**RE: Amendment Application for Gunstfontein Wind Energy Facility**

This statement letter is in reference to the authorized Gunstfontein Wind Farm (DEA REF14/12/16/3/3/2/826) and the request from Savannah Environmental (Pty) Ltd for comment on the ecological implications of the proposed changes to the layout and turbine specifications that would be included in the amendment application to the Department of Environmental Affairs.

REVIEW OF ECOLOGICAL IMPACT ASSESSMENT AND ENVIRONMENTAL AUTHORISATION OF THE  
GUNSTFONTEIN WIND FARM NEAR SUTHERLAND, NORTHERN CAPE

### **REVIEW OF ECOLOGICAL IMPACT ASSESSMENT AND ENVIRONMENTAL AUTHORISATION OF THE PROPOSED GUNSTFONTEIN WIND FARM NEAR SUTHERLAND, NORTHERN CAPE PROVINCE (DEA Ref 14/12/16/3/3/2/826).**

**Figure 1.** Revised and refined sensitivity map of the Gunstfontein WEF site, depicting the amended layout of the facility. No parts of the development are within the no-go area.

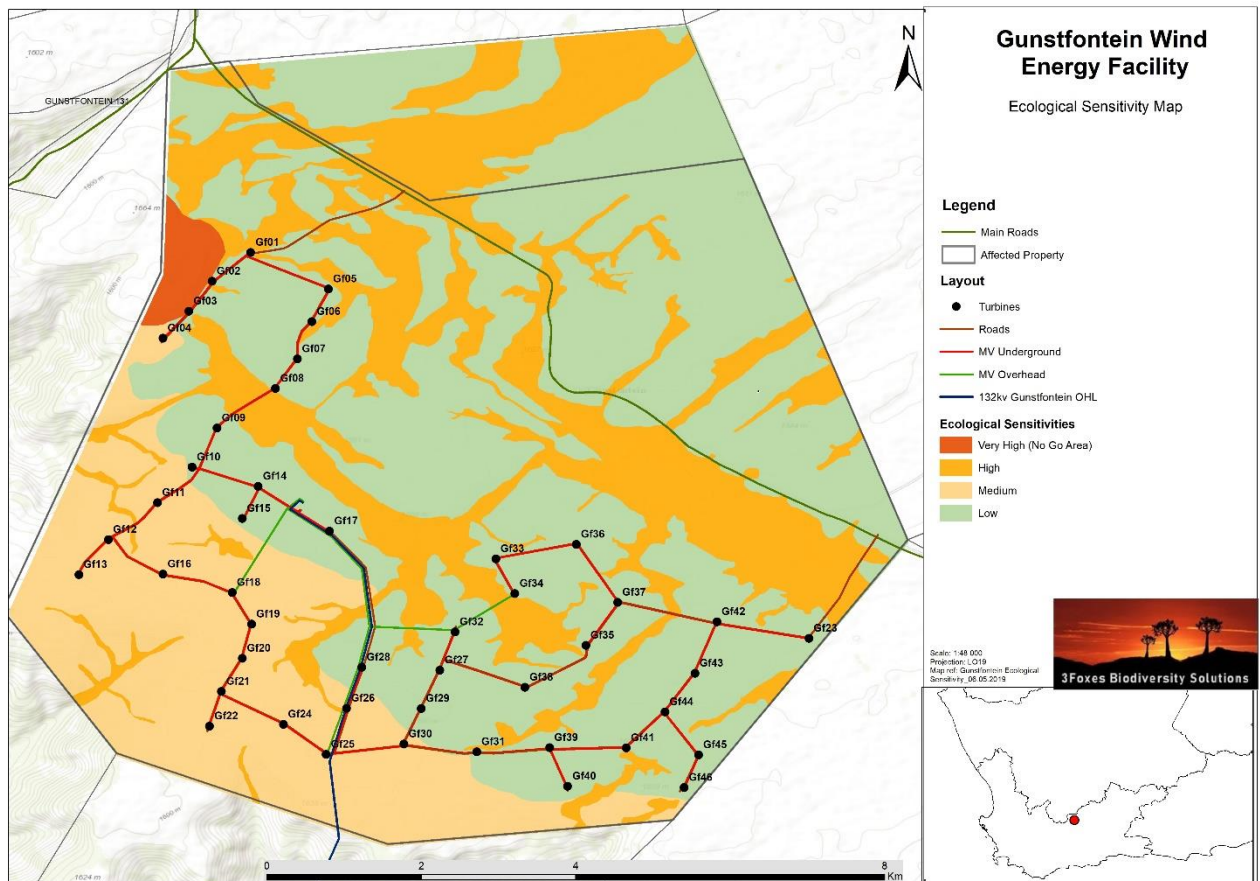
The revised layout for the amendment and the revised sensitivity mapping as produced for the amendment is provided below in Figure 1. The revised sensitivity mapping is based on the original ecological study by Todd (2016), the review and field assessment of MacDonald (2017) (see Appendix), as well as the specific field assessment that was conducted for the current assessment on the 16<sup>th</sup> of January 2019. During the field assessment for the current study, those areas that had previously been identified as high or very high sensitivity<sup>1</sup> were checked and where necessary refined in the field and specific note was taken of the presence of species or habitats of conservation concern in these areas. Where appropriate, the sensitivity of these areas was adjusted upwards, downwards or kept the same as necessary. This information was provided to the developer in the form of the revised sensitivity map, which was then used to inform the layout for the amendment. In addition to the sensitivity mapping, to ensure that the impacts associated with the project remain within acceptable bounds, limits of acceptable change associated with each sensitivity class were provided to the developer. This provides a guide for the developer in terms of ensuring that the spatial distribution of impact associated with the final layout is appropriate with respect to the sensitivity of the site. In addition, it provides a benchmark against which impacts can be assessed and represents an explicit threshold that when exceeded indicates that potentially unacceptable impacts may have occurred. The updated (including revised turbine positions and additional access road)<sup>2</sup> turbine layout is presented below in Figure 1, along with the revised sensitivity assessment. The limits of acceptable change provided to the developer are listed in Table 1.

The final development footprint in relation to the above limits of change are listed below in Table 2. The extent of the development within each sensitivity class is well-within the specified limits of acceptable change and as such, there are no fatal flaws associated with the amended layout. As there are also no turbines or other development features within the mapped no-go areas, no specific recommendations are made with regards to relocating any of the turbines or other features of the layout. As such, the final layout as provided for the amendment is considered acceptable with regards to the identified sensitive features and general sensitivity mapping at the site.

**Figure 2.** The current turbine layout in relation to the Northern Cape CBA map which has superseded the Namakwa District CBA map which was used for the original assessment.

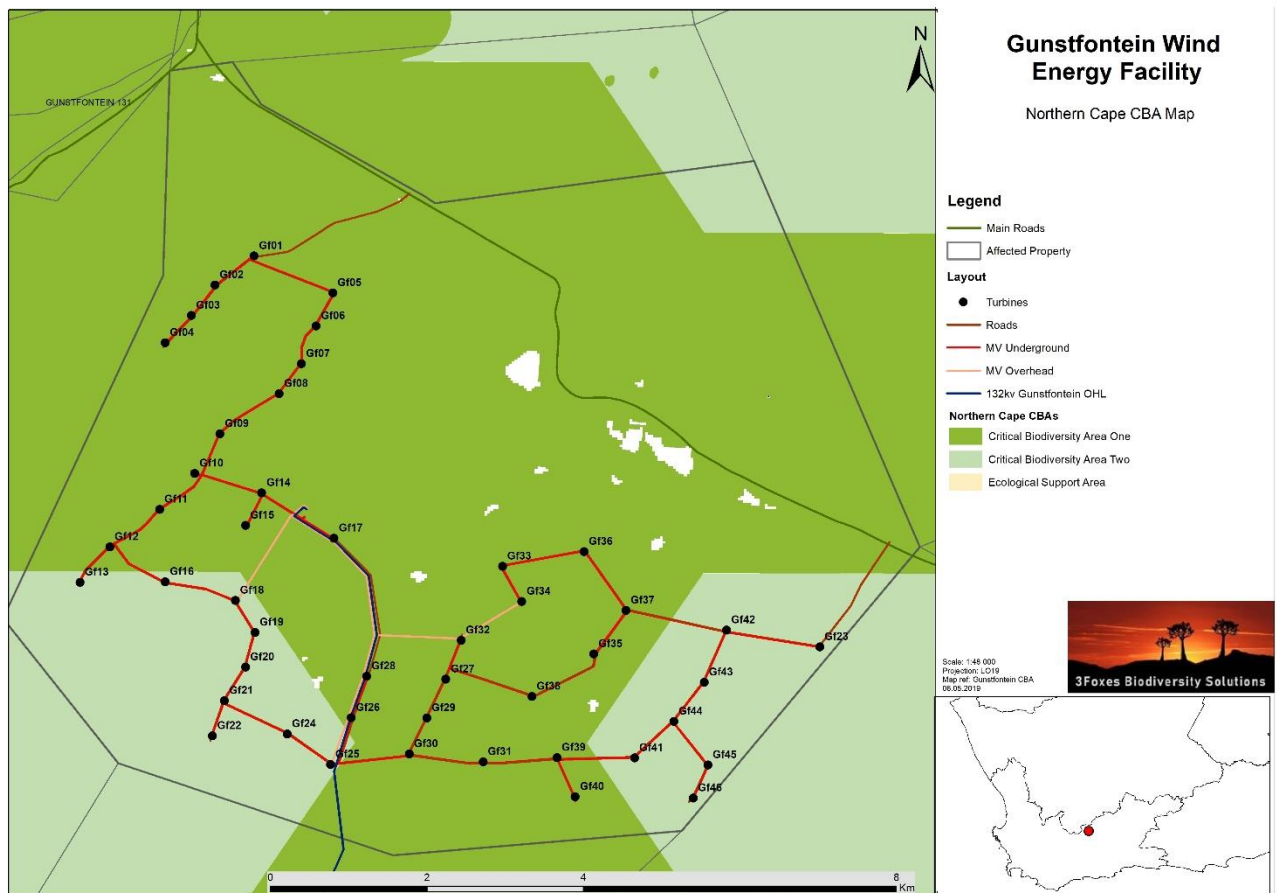
In terms of impact of the development on CBAs, no parts of the original layout were within a CBA, although the whole footprint was within an ESA. As a result, the original assessed impacts on CBAs and broad-scale processes was assessed as being of Low significance after mitigation. Similarly no parts of the amended layout is within the same CBAs as defined under the Namakwa District Biodiversity Sector Plan (Desmet & Marsh 2008). The CBA map for the Northern Cape has however been released in the intervening period between the original assessment and the current amendment. Under the more recent Northern Cape CBA map, the whole footprint is within a CBA 1 or a CBA 2 (Figure 2). If the application was for a new development, this could bring the suitability of the development into question. However, as this is an amendment, the current assessment is in relation to the original assessment and the baseline information as available at that time. Under this scenario, there are no significant differences in impact on CBAs and broad-scale processes between the original layout and the amended layout.

**Figure 1.** Portion of the VEGMAP (SANBI, 2012) indicating that all 68 of the proposed wind turbines fall within Roggeveld Shale Renosterveld.

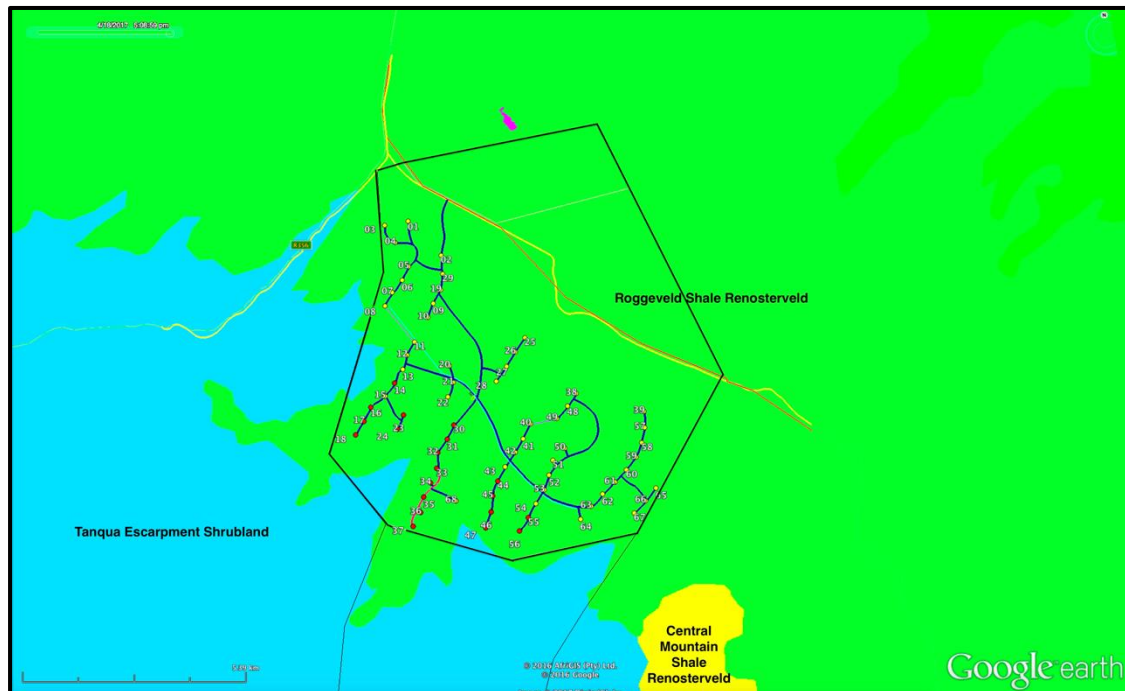
Reference to the Vegetation Map of South Africa Lesotho & Swaziland (SANBI, 2012) (VEGMAP) supports the observation that there is very low variability and only a single vegetation type (Roggeveld Shale Renosterveld) over the entire area proposed for construction of wind turbines. Variability in the landscape and ecology is found at a localised scale that is not reflected in this map. However, what it clearly shows is that no wind turbines would be located in Tanqua Escarpment Shrubland which is the vegetation type found on the slopes of the escarpment.

**Figure 2.** The Critical Biodiversity Areas map of Desmet & Marsh (2008) as applied to the Gunstfontein Wind Farm Area (black boundary). The red areas are Critical Biodiversity Areas and the green area is Ecological Support Area (Corridor).

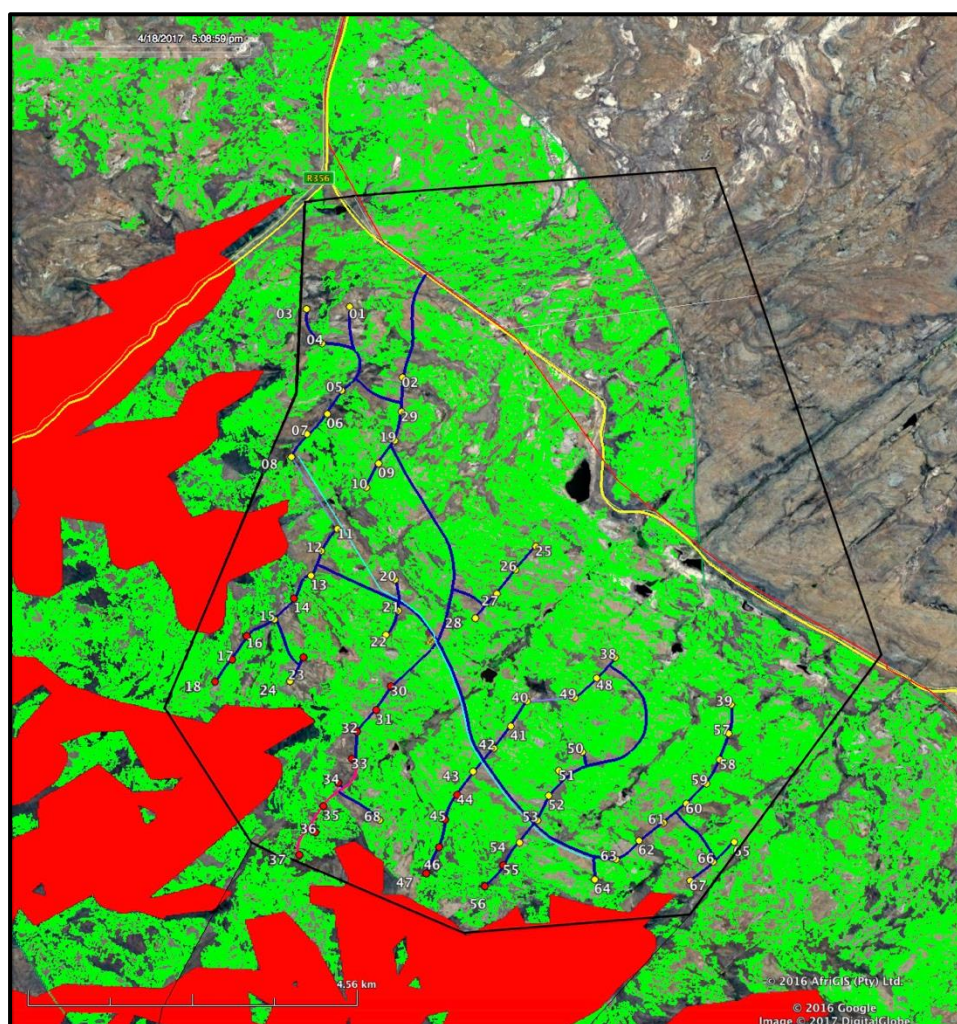
In addition to the VEGMAP the Critical Biodiversity Areas map of Desmet & Marsh (2008) for the Namakwa District Municipality was applied to the Gunstfontein Wind Farm site by overlaying the shapefiles on Google Earth. It is noted, as can be seen in Figure 2, that none of the proposed 68 wind turbines would be located

within any Critical Biodiversity Area. It is true, however, that ALL the wind turbines would be located within an Ecological Support Area (Corridor) as mapped by Desmet and Marsh (2008) (Figure 2). It is also true that the development area falls within the Sutherland- Kamiesberg SKEP Expert Plans Priority Area and within the Bokkeveld-Hantam-Roggeveld Priority Area (Point 4.12 in Appeal Decision document). However, the latter two 'priority areas' are irrelevant in determining the sensitivity of turbines at a site-specific scale. These are broad-scale biodiversity determinants used to inform regional planning activities, and are not an indication of localised (site-specific) sensitivity. In this case much more focused questions of site sensitivity are being considered. If the argument that these broad-scale areas are important and a determinant to disallow turbines, then all the turbines at Gunstfontein as well as at other wind farms in these priority areas should be disallowed. It is thus important to keep focus on the site itself and not confuse this with broader-scale biodiversity sector plans that are merely general informants.

The proposed turbines at Gunstfontein would not impact on broad-scale ecological functioning i.e. the ecological support areas *sensu* Desmet & Marsh (2008) would continue to function without hindrance; the wind farm would be compatible with the ecological processes and functioning on the site.

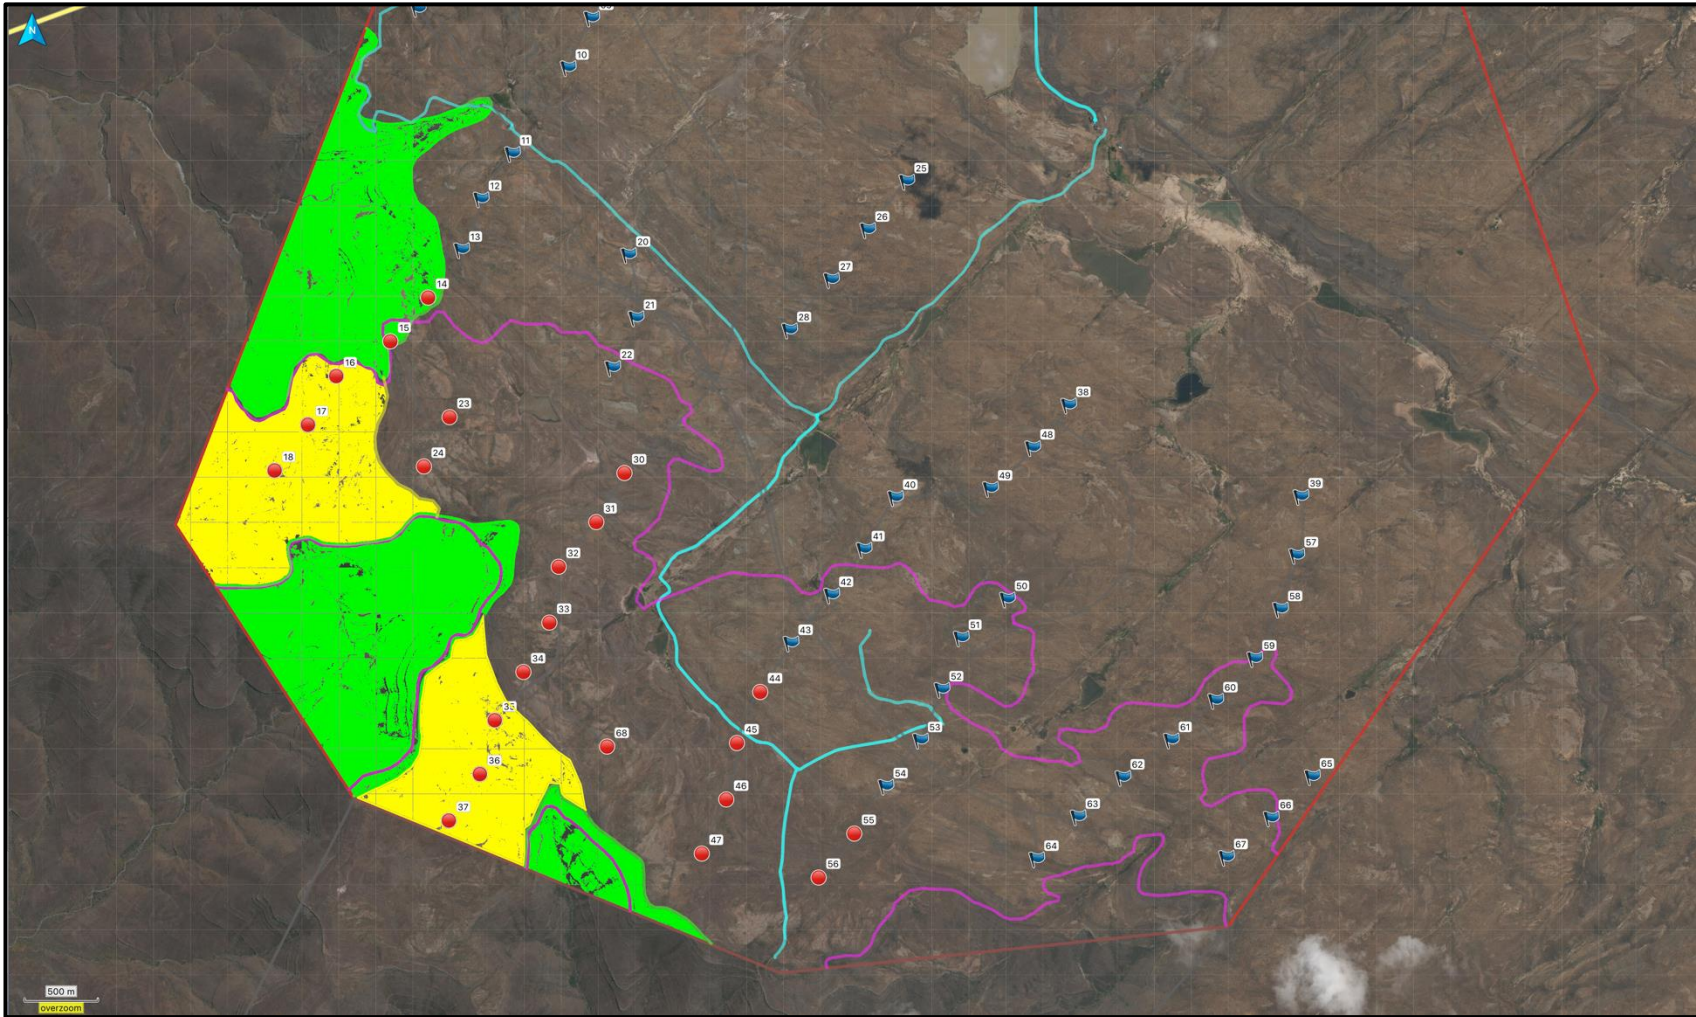
I have plotted the wind turbines that have to date been disallowed by DEA on an aerial photograph with superimposed contours. I have then, from my on-site observations and from interpretation of aerial imagery (Google Earth, Bing and Garmin Birds-eye imagery), mapped what I consider to be the sensitivity of the site. The sensitivity map I have compiled is presented in Figure 3 and differs to some degree from Todd's (2016) sensitivity map. According to the sensitivity map I have compiled, the only HIGH or VERY HIGH sensitivity areas are located in the south-west portion of the site towards the escarpment. In my assessment, the remainder of the site is of medium to low sensitivity. It can be seen that a total of eight turbines fall within the HIGH sensitivity areas that I have mapped, specifically turbines 14-18 and 35-37. However, despite the relative higher sensitivity in these areas, the proposed turbines are still considered acceptable subject to micro-siting and mitigation. Although the sensitivity mapping shown in Figure 3 differs from that of Todd, our findings are essentially aligned i.e. the proposed layout of the Wind Farm is acceptable in terms of terrestrial ecology.

Point 4.14 of the Appeal Decision document (DEA) states, 'The Department submits, therefore that it maintains the view that the placement of turbines and infrastructure on areas in the high sensitive escarpment must be avoided'. This position is not disputed, however, the definition of the high sensitive (sic) escarpment requires clarification. According to my on-site observations the escarpment is found below 1 580 m above mean sea level (a.m.s.l.) on the south and south-west sides of the Gunstfontein Wind Farm area. If the proximity to the edge of the escarpment is used as the criterion by which to exclude turbines, then all 68 turbines should be included in the Environmental Authorisation since none of those on the 'plateau' on the south and south-west side of the Gunstfontein Wind Farm area (as currently disallowed by DEA) would be located below 1 580 m a.m.s.l. i.e. near the edge of the escarpment.
